Plan Amendment - Pk. lot

TO: Kandi Talbot – Planner
FROM: Jim Seymour – Development Review Coordinator, Sebago Technics, Inc.
RE: Parking Lot Improvements – 535 Ocean Avenue
DATE: November 4, 2002

**RE: 535 OCEAN AVENUE, PORTLAND
AMENDED SITE PLAN APPROVAL – STAFF REVIEW**

535 OCEAN AVENUE
PARKING LOT IMPROVEMENTS
Portland, Maine

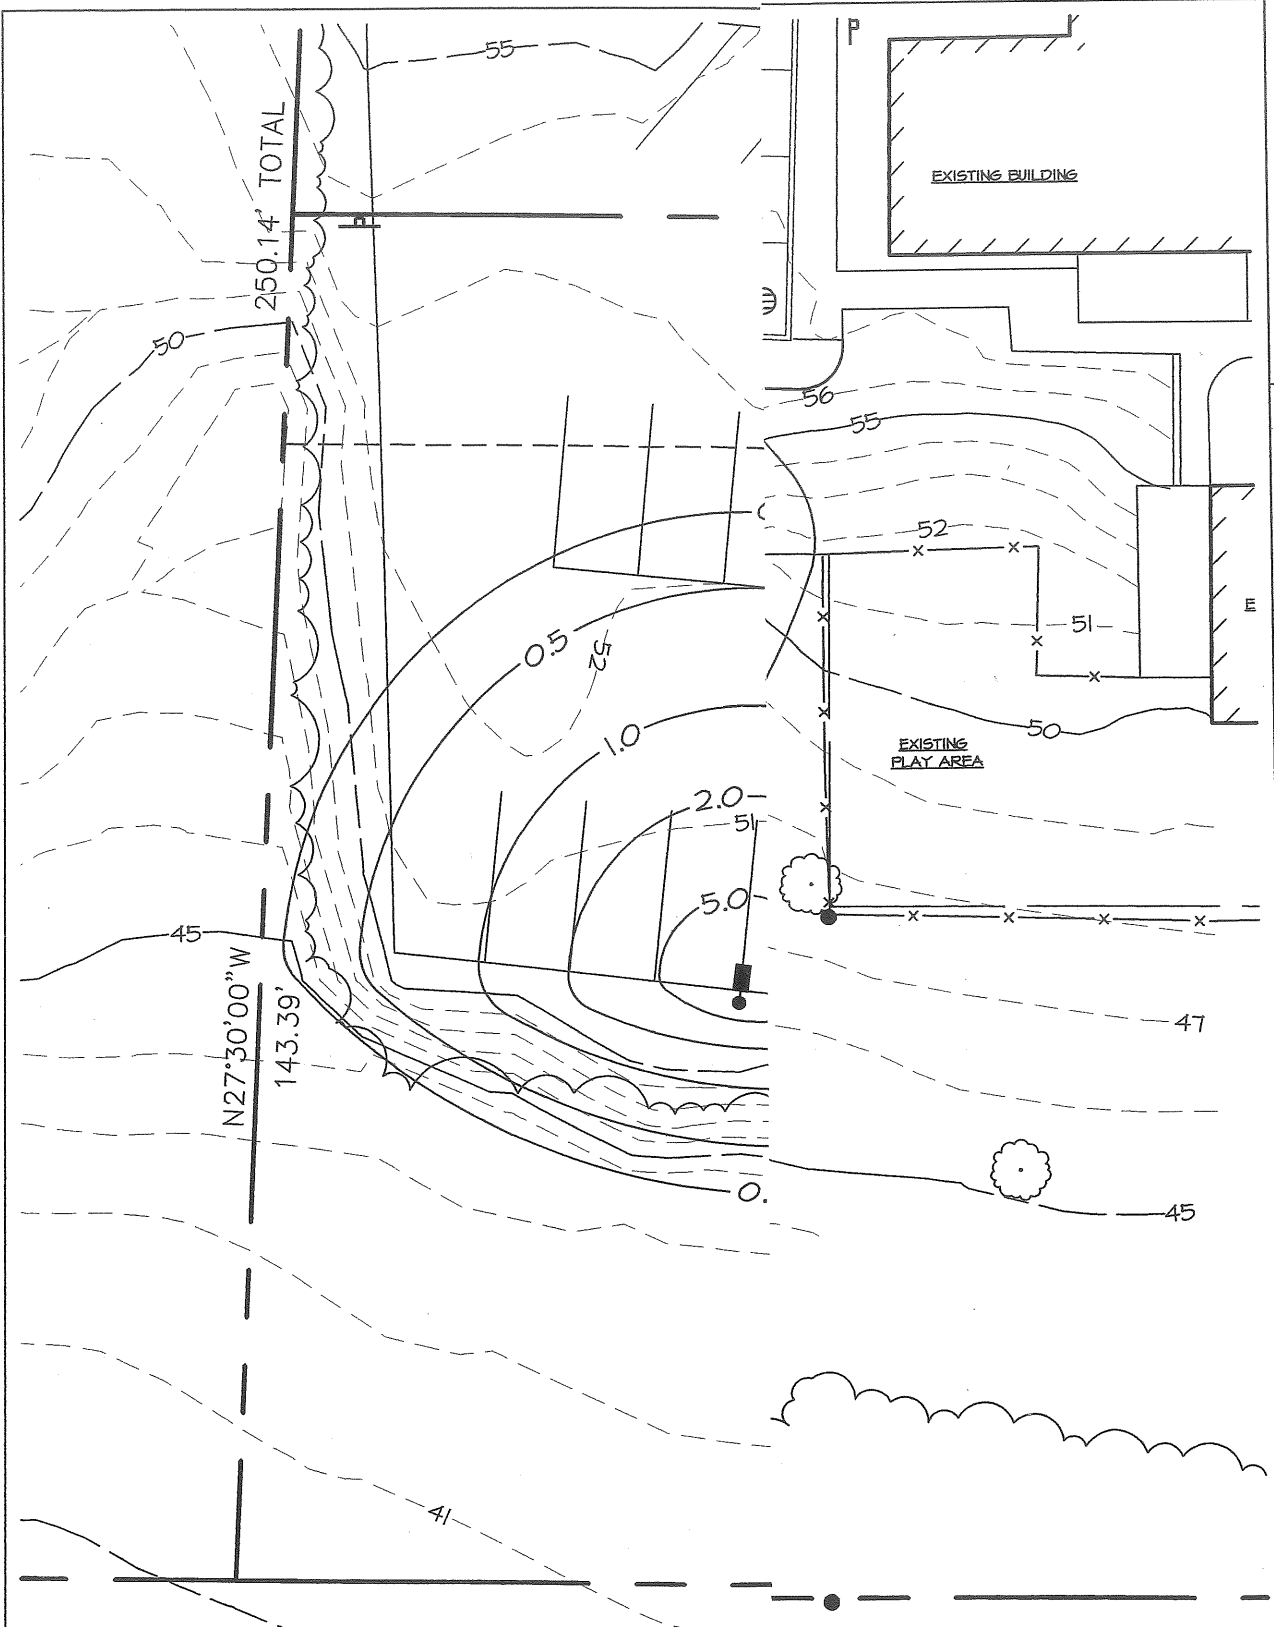
3. Pavement Joint: Revised Sheet L5.0 shows a pavement joint detail where the existing pavement meets the proposed pavement.
4. Photometric Plan: Mohr & Seredin submitted a photometric plan for review by Planning staff on October 30, 2002. Attached is another copy of this photometric plan. Note there is no light spillover onto abutting properties.

3. A "pavement joint" detail must be added to the detail sheet.
4. A photometric plan shall be submitted showing that the light fixtures proposed will not spillover onto abutting properties and meet the City's lighting standards.

LIGHTING AND PHOTOMETRICS NOTES:

1. ALL PROPOSED LIGHTS SHALL BE 100-WATT 15-FOOT. LIGHTS SHALL 'FORM 10 -- EB STYLE
2. ALL LIGHTS SHALL CONTAIN INTERNAL HOUSING
3. ALL UNITS IN THE ABOVE PLAN ARE SHOWN IN METRIC SCALE
4. PHOTOMETRIC DATA SOURCES ARE THE IESNA LUMINAIR DATA CENTER, SAN LEANDRO, CALIFORNIA (1-800-227-0758)

4. CALCULATE POST DEVELOPMENT PEAK FLOWS.

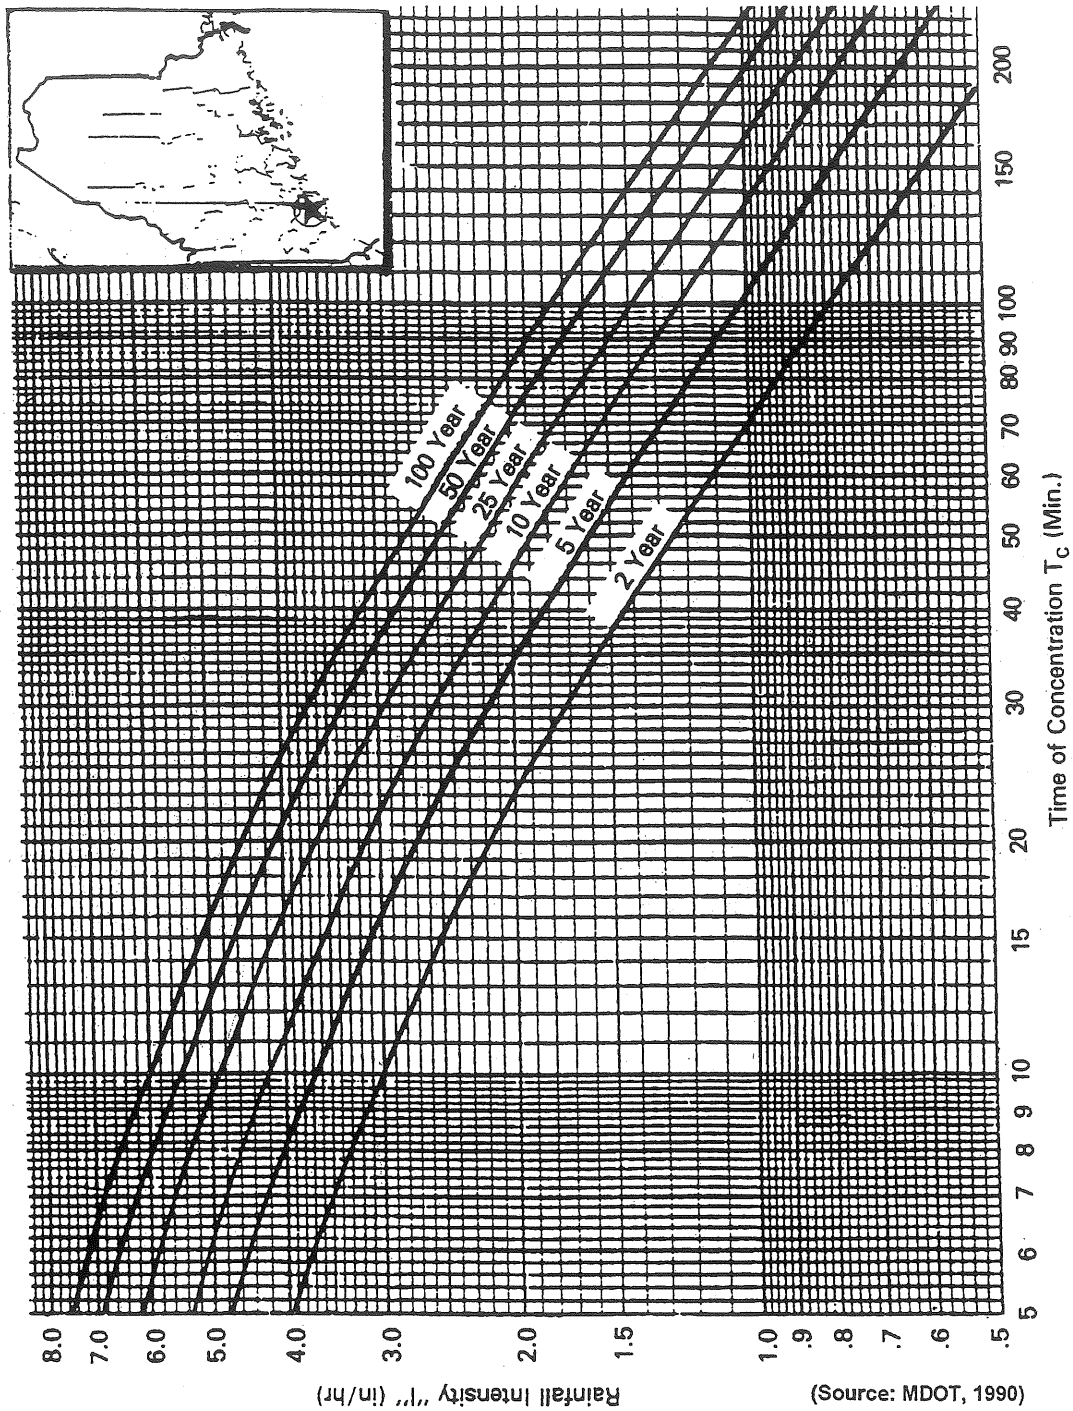
1. Please provide stormwater runoff calculations and the anticipated runoff increases for the appropriate storm events as well as sizing calculations for the proposed culvert and level-lip spreader. Please also provide a brief description of the soil types and their "hydrologic soils group" classification used in the runoff analysis.

$$Q_2 = (0.67)(3.0)(0.18) = 0.36 \text{ CFS.}$$

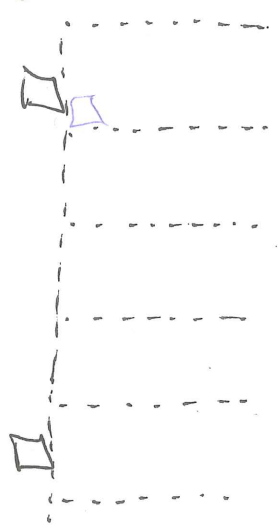
4. The light poles were installed prior to paving, and the energetic paving team paved around their bases. Knowing this was a concern of yours, when we had the striping done, we made sure that the leading edge of the spaces very clearly started medial to the bases of the lightpoles (see diagram).
